June 29, 2022

Mr. & Mrs. Ezra Berry originally applied for 8 variances for the construction of a swimming pool with raised spa, patio, roof over patio with an outdoor kitchen and a sports court. The Berry's have worked with their engineers and reduced the numbers of variances requested to 5.

GRADING & DRAINAGE PLAN
 OF PROPERTY
 INCORPORATED VILLAGE OF WOODSBURGH
 41-39-767

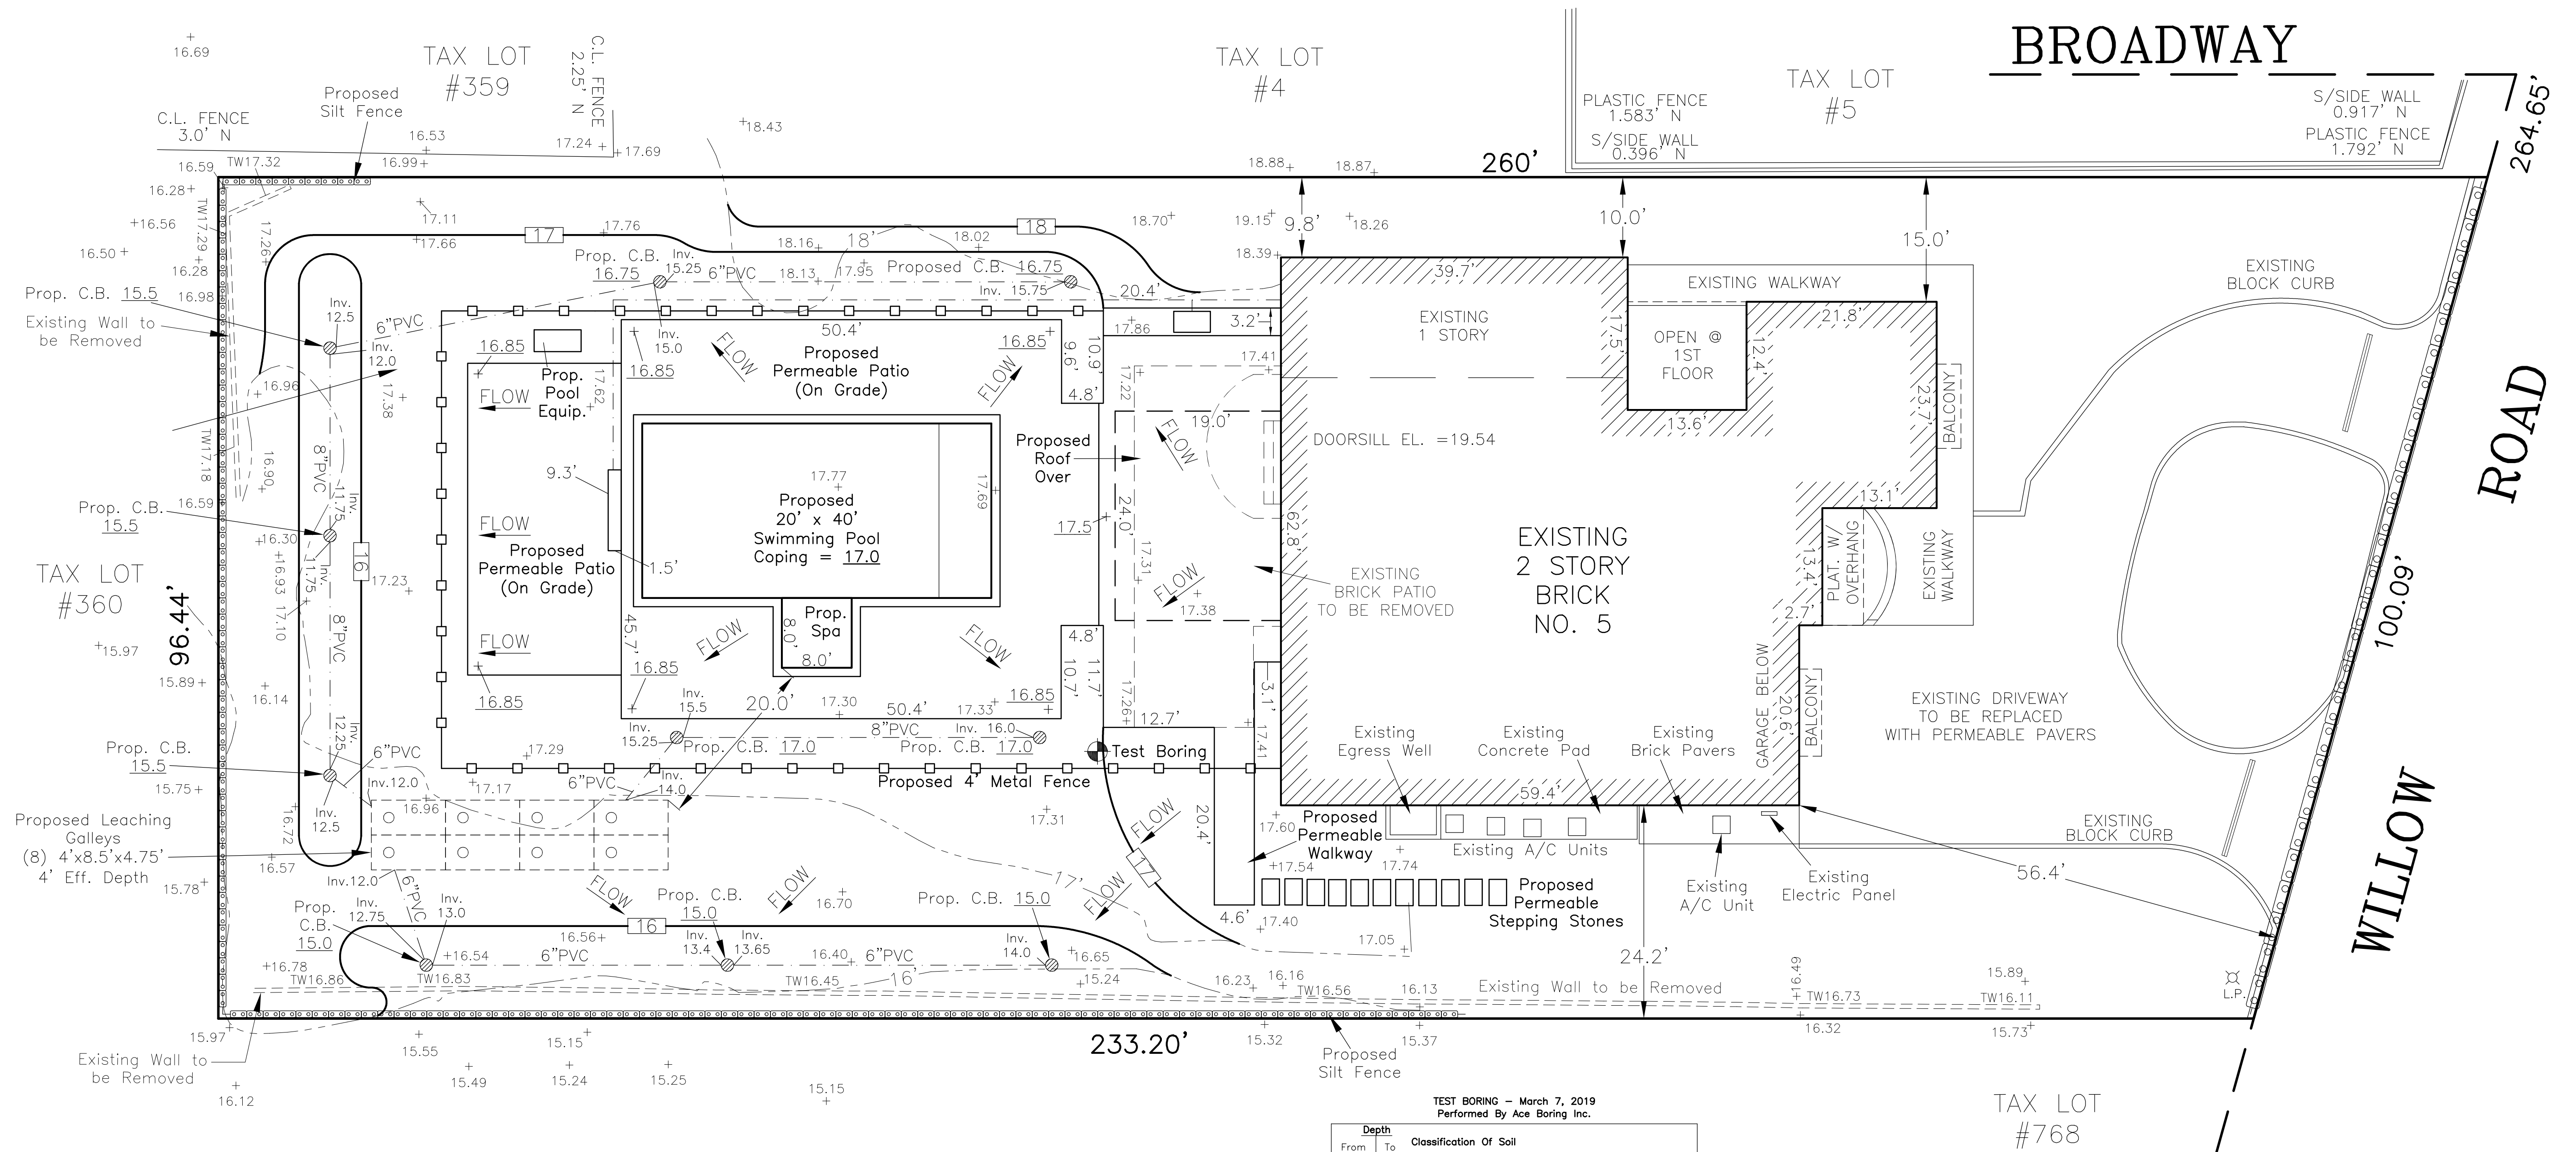
1. Code §150-39. B Maximum impervious lot coverage is 7,467.46 SF. *Originally proposed impervious lot coverage is 11,351 SF.*
 - a. **New Plan is compliant with an impervious coverage of 6,091.2 square feet.**
2. Code §150-39. E Accessory buildings and structures are not permitted in a front yard. Originally proposed Existing H frame utility structure is in a front yard.
 - a. **New Plan is compliant with the H frame removed and the utility located on the southeast wall of house.**
3. Code §150-39. G (9) Sports Court
4. Code §150-39. G (1) Sports Court
5. Code §150-39. G (9): Sports Court
 - a. **Sports Court is being removed from the plan.**

1. Code §150-39. A Residence B: Max 15% or 3,567.32 SF. Originally proposed lot coverage is 22.3% or 5,293.8 SF.
 - a. **The new proposed lot coverage will be 19.3% or 4,580.3 square feet.**
2. Code §150-47. B Swimming Pool fences shall not be located less than 25 ft from the rear lot line and not less than 25 ft from the side lot line. Originally proposed fencing located 3 ft from the side and rear lot lines.
 - a. **The new proposed pool fencing will be 15.3 ft from the northeast side lot line and the other 3 sides will be code complaint.**
